ITEM FOR ENVIRONMENTAL BOARD AGENDA

NAME & NUMBER OF PROJECT: TRAVIS COUNTY EASTSIDE SERVICE CENTER
SP-2008-0235D

SUBJECT: Travis County Eastside Service Center – SP-2008-0235D

Variance Requests: Variance from LDC 25-8-341/342 – To allow cut greater than 4 feet but not to exceed 12 feet and to allow fill greater than 4 feet but not to exceed 10 feet

CUT/FILL
EXHIBIT

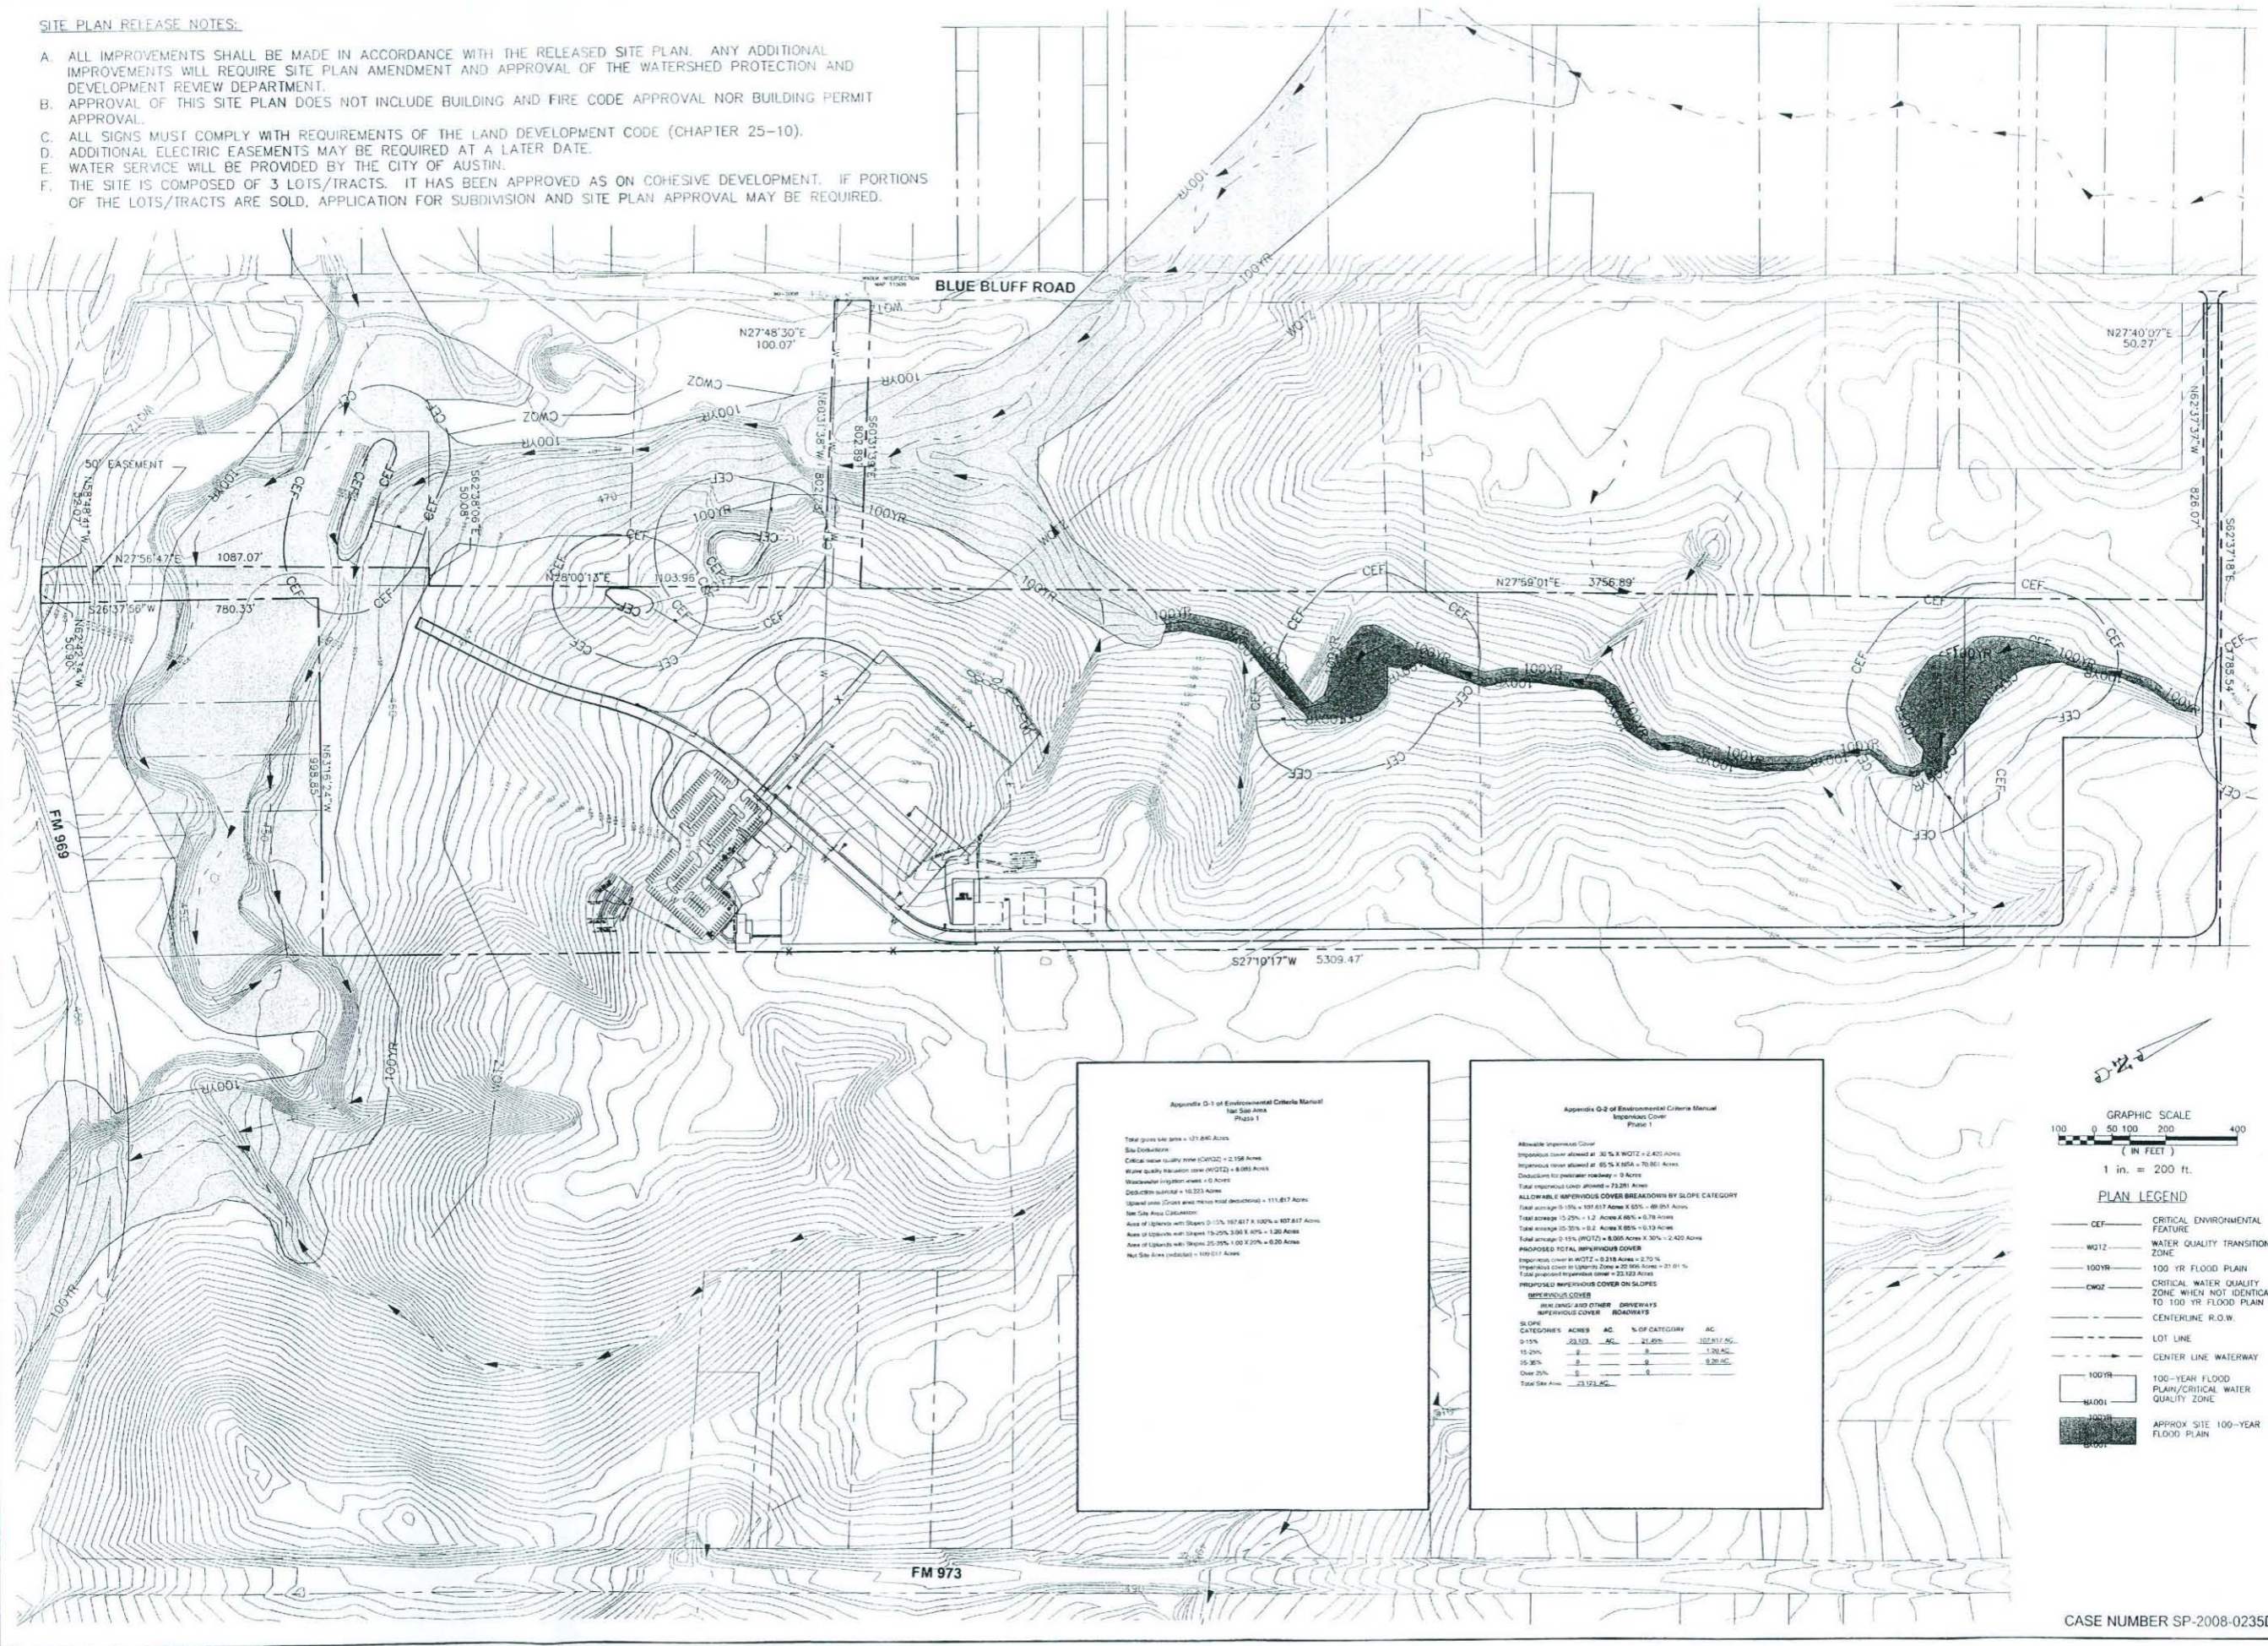
Areas of cut up to 12 feet on site were utilized as borrow areas to provide fill up to 10 feet. Cuts up to 12 feet were placed for the construction of the Fleet Services Building. Cuts up to 12 feet and fill up to 10 feet were placed for the construction of Detention Pond 'B'. Fill up to 10 feet was placed for the construction of a parking area adjacent to the Administration Building. Fill up to 8 feet was placed for the construction of Detention Pond 'A'. Please see the attached cut/fill exhibit for graphics on cut/fill.

We hereby request a variance for cuts to depths of approximately 12' and fill heights to approximately 10' located within the above referenced site; these respective depths and heights are the most severe occurrences within the project. The attached **Cut/Fill Exhibit** indicates the multiple locations of cuts and fills exceeding 4' throughout the project limits for which this request is made. The two most severe instances of cut and fill are characterized as follows:

Both cut and fill associated with a site detention facility, Pond 'B' located near the center of the tract reach the extremes referenced above. The fill areas extend from the inlet swale at the west side of the pond to heights nearing 10' in depth and transition to cut at the east toe of the pond. The fill areas also create the containment berm along the north side of the pond. The cut areas extend to the eastern limit of the pond extending to a depth of nearly 12' inside the pond. Due to the size of the pond and the relatively severe existing slopes adjacent to this natural drainage feature resulted in the need for these cuts and fills at this location. Plan Sheet 17, Detention Pond 'B', provides the full extent of grading associated with this facility. This pond is necessary to attenuate the storm runoff from the site to existing conditions flows for all downstream areas.

A narrow fill area approximately 310' in length that extends along the south and west edge of the driveway and public parking area to the east of Buildings 'A' and 'B' reaches a fill depth of nearly 10'. Slopes of 5 percent are used along this drive and the east-most areas of the parking lot to attempt to minimize the fill while still providing reasonable slopes to patrons traversing these areas on foot. Both building finished floors were placed in cut to attempt to minimize these fills, yet they are still required while meeting accessibility requirements at each building.

1. An upland zone conservation easement of at least 4 contiguous acres will be established on site in an area to be agreed upon by Staff and the Applicant.
2. Areas of disturbance within the wetlands CEF's require 609S reseeded.
3. No coal tar based sealants will be used for Phase 2.
4. The Applicant will provide an IPM plan.
5. 609S reseeded will be applied in the wetland CEF setback containing Detention Pond 'A'.
